CITY OF LEE'S SUMMIT
Development Services Department
220 SE Green Street
Lee's Summit, MO 64063
(816)969-1200

Inspection Summary

Permit #: PRCOM20235733

Address: 209 SE GREEN ST, LEES SUMMIT, MO 64063209 SE GREEN ST, Unit:IR, LEES SUMMIT, MO 64063

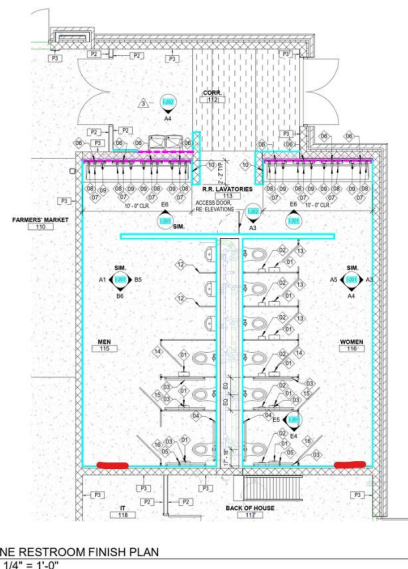
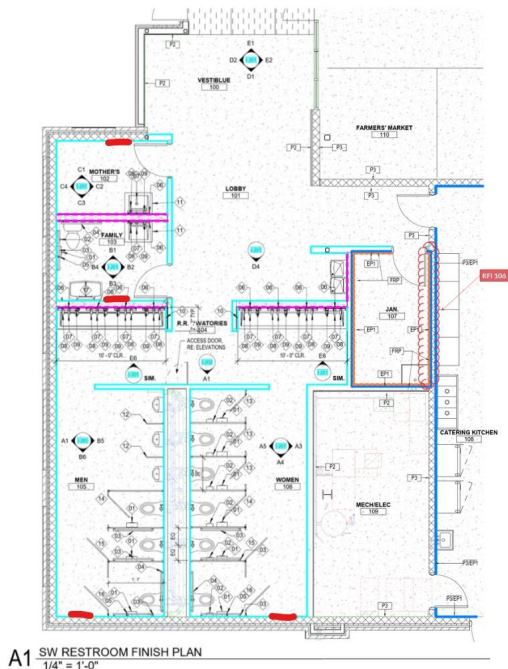
5)Accessible Mirrors. Contractor needs to install one full length mirror. Doing

so will meet the intent of the IBC for accessibility purposes. Revis plans showing the accessible mirror and location of sinks. **See mirror information below**

Comments: The top of the mirror should be roughly 80" AFF. We need to be 74" AFF to top of mirror and the lower edge can be no higher than 35" which shouldn't be a problem with a 60" tall mirror. We will need 6 mirrors, one for each restroom and the Family and mother room. In the below sketch we would place them in the red line locations. We are putting the new mirrors at the far end of the restroom so that they are near the ADA stall and don't introduce any sight line issues.

Initially, we considered requesting a variance due to the fixed height of the installed mirrors. However, after further discussion with the owner, we are moving forward with the installation of **full-length mirrors** in each restroom near the ADA stalls. This solution not only addresses accessibility concerns but also enhances usability for a broader range of individuals.

A single full-length mirror can accommodate a greater number of people, including children. In order for mirrors to be usable by people who are ambulatory and people who use wheelchairs, the top edge of mirrors should be 74 inches minimum from the floor or ground.
